Project:	Highways England Spatial Planning Arrangement	Job No: 60572359 DM014.003/0 04
Subject:	South Caldecotte VISSIM Audit	
Prepared by:	Alejandro Pina/ Alex Clewes	Date: 12/10/2018
Checked by:	Javier Pardo	Date: 16/10/2018
Verified by:	Phil Arnold/Liz Judson	Date: 16/10/2018
Approved by:	John Alderman	Date: 02/11/2018

This technical note consists of a modelling audit of the A5/A4146 Kelly’s Kitchen Roundabout VISSIM models, provided by BWB to support the proposed South Caldecotte development south of Milton Keynes. The audit includes a review of demand development, base model calibration/validation and forecast model audit. The audit was carried out based on WebTAG guidance and best practices based on the VISSIM Model Audit Process (VMAP) from Transport for London.

- 1.1.1 This Technical Note (TN03) provides a summary of the auditing work conducted for VISSIM models developed for the A5/A4146 Kelly's Kitchen Roundabout by BWB. The VISSIM models have been provided to support a proposed employment development site at South Caldecotte, to the south of Milton Keynes. This Technical Note should be read alongside Technical Note 01 (TN01), which documents the review of the Transport

Figure 2. Network coding error.

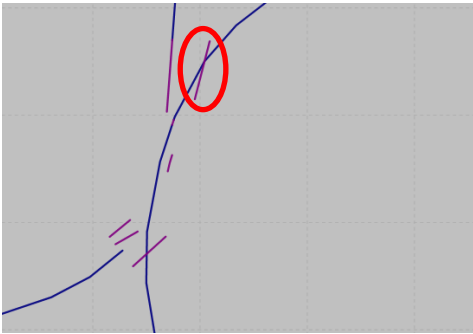
2.4.1 The use of overlapping connectors to manage static routes is considered acceptable, but the length and location of these “routing connectors” should be chosen to minimize any possible overestimation of the capacity. As shown in Figure 2 below, the “routing connectors” used in the base model are too long and too close to a signal head, where the queue will extend back and cause capacity overestimation due to vehicles queuing on top of each other.

Figure 4. Inconsistent detector definition.

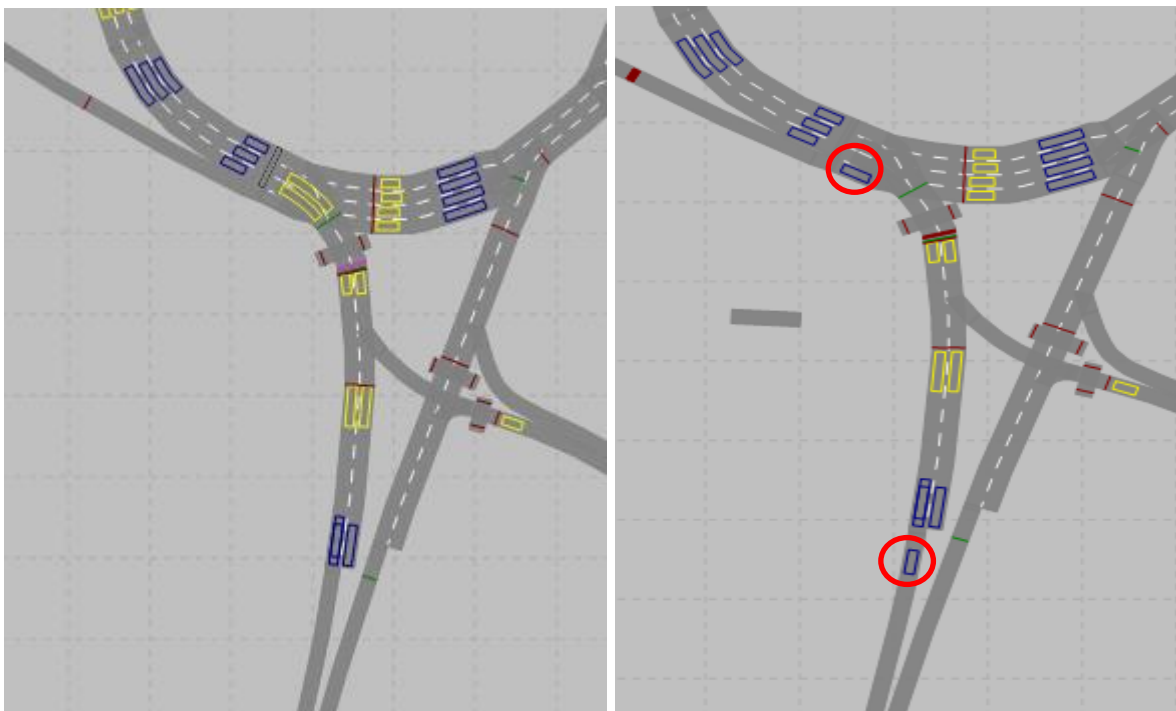
2.6.1 There are inconsistencies between the detectors coded in AM and PM models (see Figure 4). Detectors are considered a network element which represent physical loops in the road and should be exactly the same in both models. The presence of these detectors is likely to affect the signal operation and green time distribution at the roundabout. The signal synchronization could be improved based on site observations of survey video footage – for example, there is underutilized green time on the A4146 approach.

Figure 5. Missing Signal heads

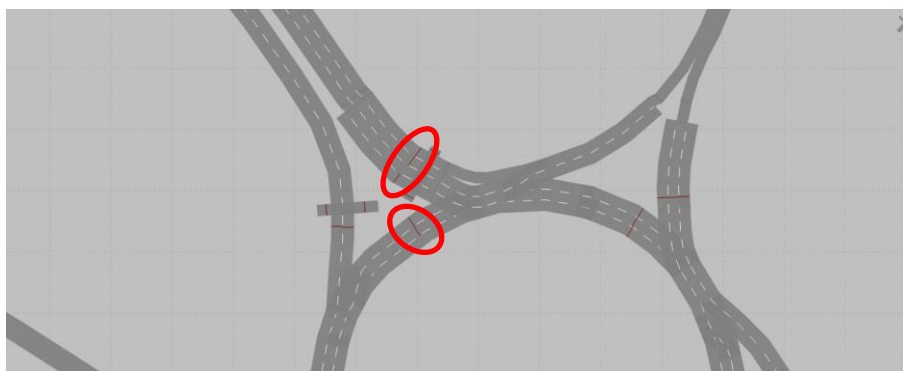
2.6.2 Additional errors have been identified in the 2017 Base model’s signal controllers associated with signal heads (see Table 1). Moreover missing signal heads have also been identified in the 2023 Future Base PM model.

Figure 6. Priority rules coding.

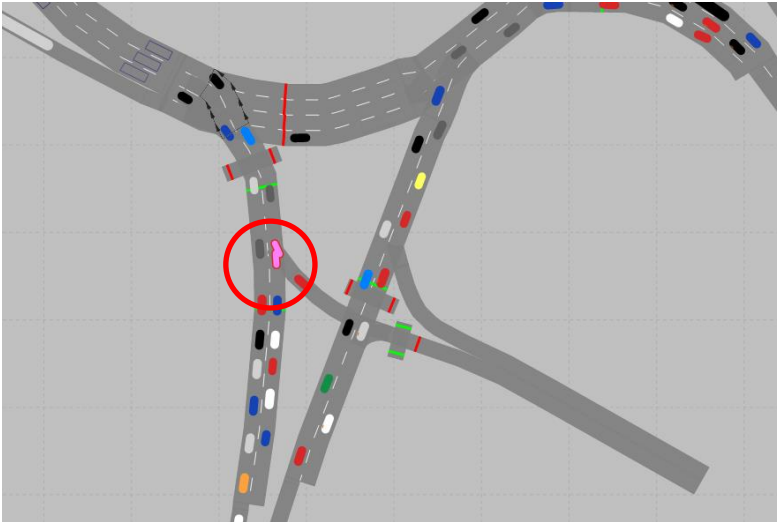
2.7.1 The priority rules coded in the model are not calibrated, producing unrealistic behaviour and overestimating the capacity. Due to the proximity of the signal head the likely impact on this model would be **MINOR**. However, if the congestion and traffic through the junction increases or the capacity of the approach increases it may cause additional delay. See Figure 6 for an example of incorrectly coded priority rules.

Figure 9. 70 mph speed distribution.

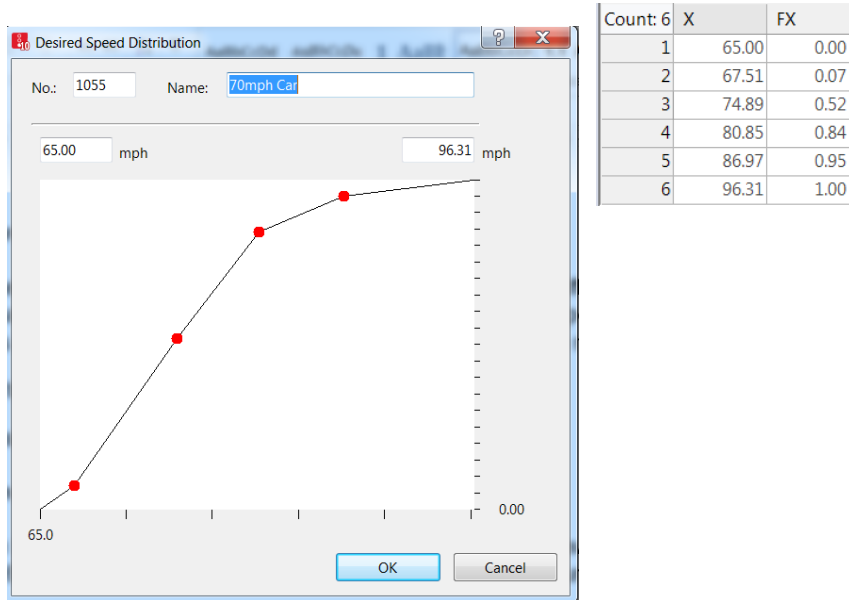
- 2.9.1 Several speed distributions have been set up in the models, but only 3 distributions have been used in desired speed decisions (40mph, 60mph and 70mph). The lower and upper limits in all these distributions are considered unrealistic unless additional proof is provided.
- 2.9.2 As shown in Figure 9, the 70mph speed distribution will set up a minimum speed of 65 mph with 93% of the vehicles with a speed higher than 67.5 mph. This distribution will result in 48% of the vehicles above the speed limit. Similar issues have been observed on 60mph speed distribution (81% of vehicles above the speed limit) and 40mph which has no distribution at all.

2.9.3 The impact of the way speed distribution has been applied on the accuracy of results is estimated to be **SIGNIFICANT**.

Figure 10. Unrealistic signal operation differences between AM and PM.

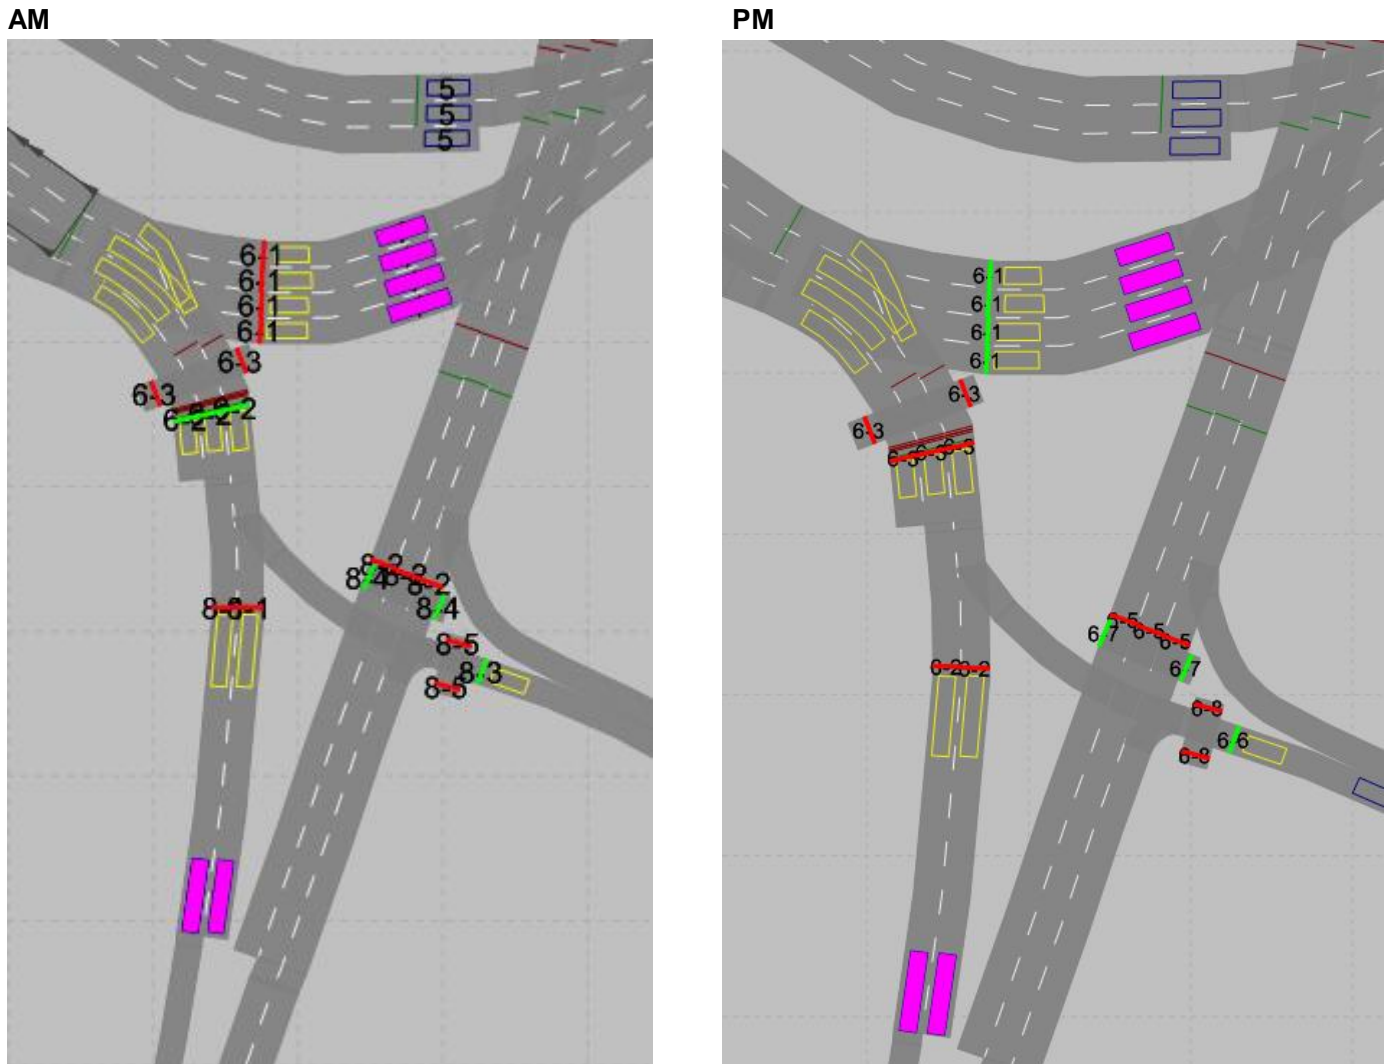
- 4.4.2 The signal controllers associated with signal heads in links No. 5, 15, 16, 28, 37, 40 and 41 are different in the AM and PM peak models. This is consistent in all the forecast models and layouts. This is due to the use of different signal controllers between the AM and PM peak, which will affect the synchronization and general operation of the model. Signal operation (e.g. maximums) could change between the AM and PM peak, but the signal logic (controller) should be the same for both peaks. The use of different controllers causes situations as shown in Figure 10, which produces underutilised green time with an unrealistic behaviour.

4.4.3 The use of controllers 6 and 8 has been observed in all the AM forecast models, while the PM uses the combined controller 6 for both junctions. This is also an inconsistency between base and forecast models, where AM and PM base models include controllers 6 and 8 in all the scenarios. The use of the same controller for both junctions will not represent the signal operation on site. Based on the signal information provided, the junction from the petrol station is controlled by a different stream and it is not linked to the signals on the A4146 approach.

Figure 14

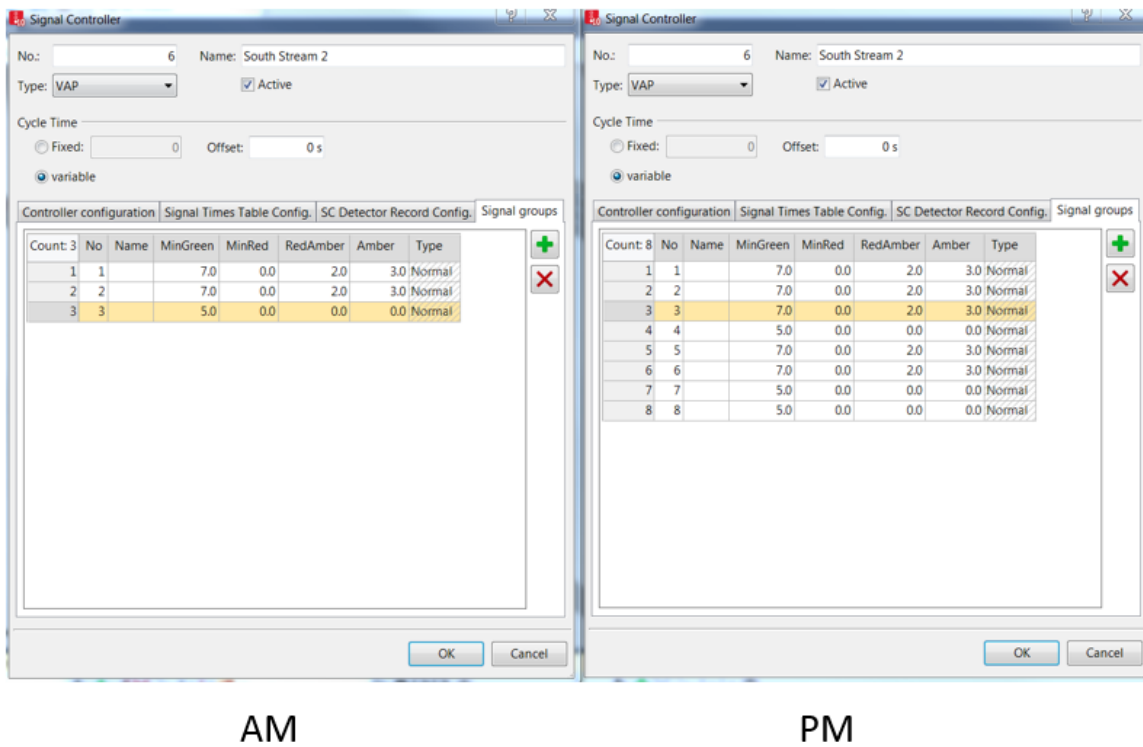
The previous error associated with signal controller 6 can be also seen in Figure 14. This error is true for forecast models 2023 Base + Com, 2023 Base + Com + Dev, 2031 Base + Com and 2031 Base + Com + Dev.

Figure 15

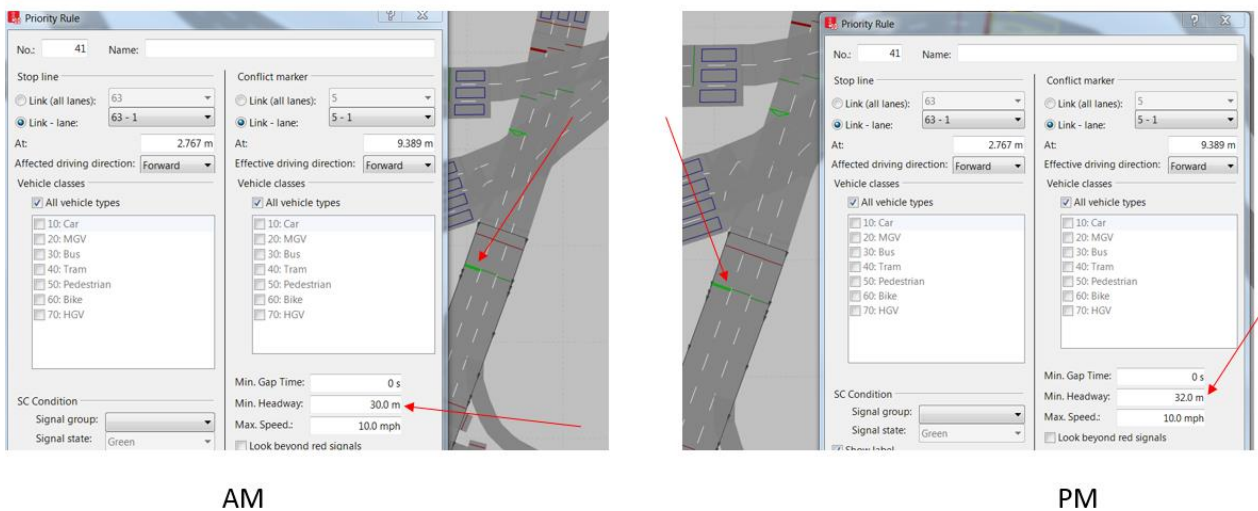
Min. Headway has been coded differently between the AM and PM in priority rules No. 39-41. Figure 15 below gives an example of one of these errors. This error is true for forecast models 2023 Base + Com, 2023 Base + Com + Dev, 2031 Base + Com and 2031 Base + Com + Dev.

Figure 16

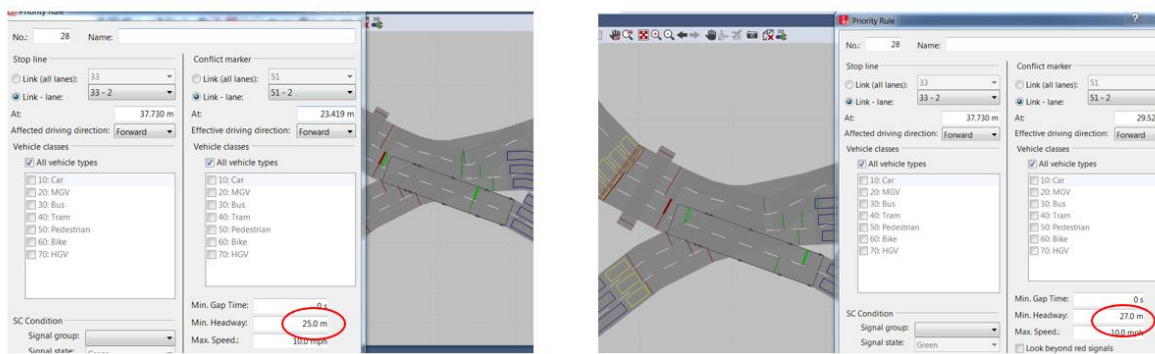
Min. Headway has been coded inconsistently for priority rules No. 28, 32 and 44 (see Figures 16, 17 and 18). This error is true for forecast models 2023 Base + Com, 2031 Base + Com and 2031 Base + Com + Dev.

Figure 20

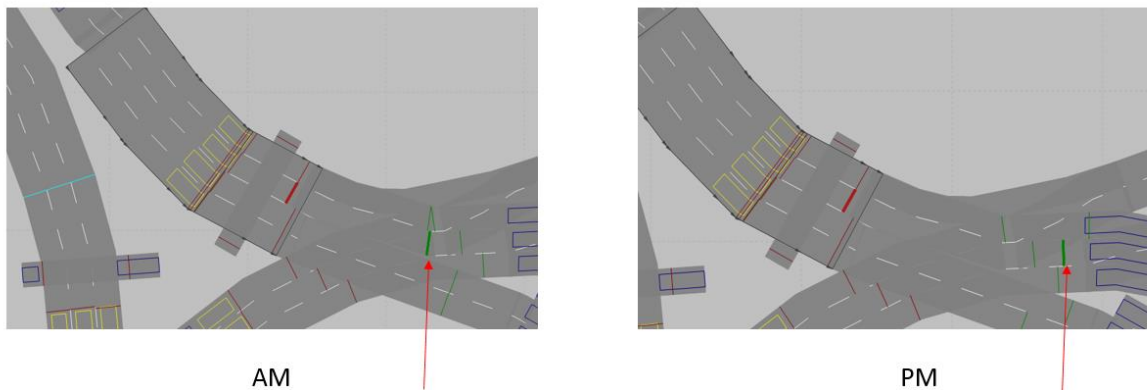
There is a discrepancy in the coding of conflict markers for priority rule No. 31 (see Figure 20). This is true for forecast models 2023 Base + Com and 2031 Base + Com.

Figure 21

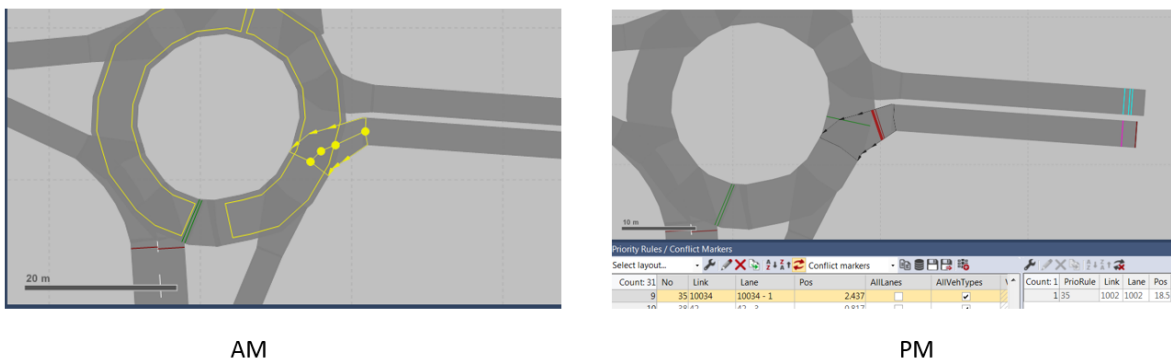
The AM peak network model does not have a priority rule equivalent to No. 35 in the PM peak network model. This is true for forecast model 2023 Base + Com (see Figure 21).

Figure 22

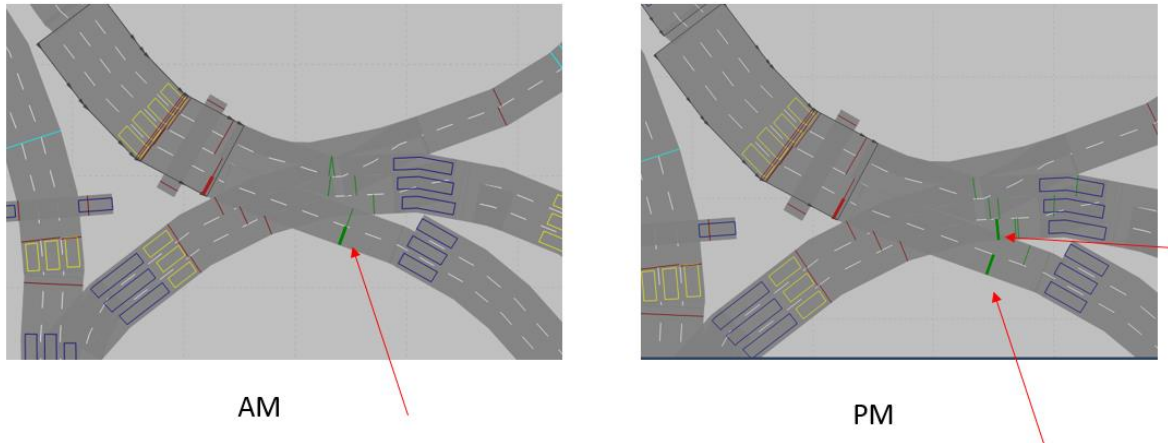
There is a discrepancy in the number of conflict markers assigned to priority rule No. 27 in the forecast model 2031 Base + Com (see Figure 22).

Figure 26

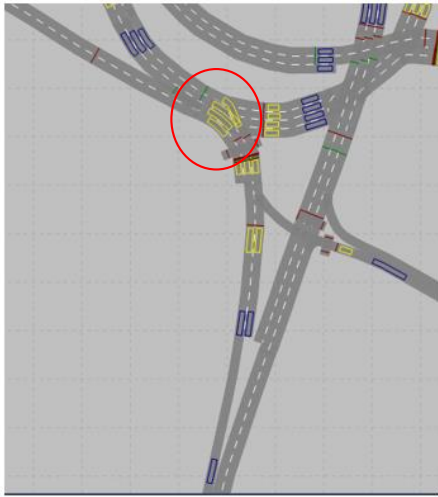
An error with the coding of reduced speed areas and detectors was found in the forecast model 2023 Base + Dev (see Figure 26). The same error was found in all base models, but have been corrected in all forecast models except the 2023 Base + Dev. This error is present both within and between the peak network models for forecast model 2023 Base + Dev.
